PRODUCT
SUPPORT
BULLETIN # 332

TOOL(S) \ PRODUCT(S) AFFECTED

SUBJECT: GEAR TRAIN SLIPPAGE - 06-57-0500 1/4"-28 LOCK NUT

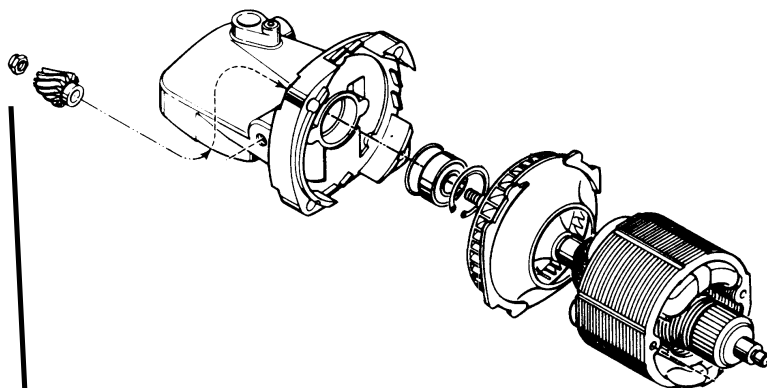
IMPORTANT! THIS SERVICE BULLETIN COVERS ALL 7" & 9", 13 & 15 AMP SANDER/GRINDERS USING EITHER THE **16-50-1185** OR **16-70-0300** 120 VOLT ARMATURE AND 06-57-0500 1/4"-28 ARMATURE PINION LOCK NUT (*see TO INFORM YOU / PRODUCT SUPPORT BULLETIN # 298 , # 314 and #318).

DURING SERVICE AND RE-ASSEMBLY OF SANDER/GRINDER, 06-57-0500
1/4"-28 ARMATURE PINION LOCK NUT SHOULD BE TIGHTENED TO
125-135 IN-LBS. OF TORQUE

NO THREAD ADHESIVE SEALANT IS REQUIRED
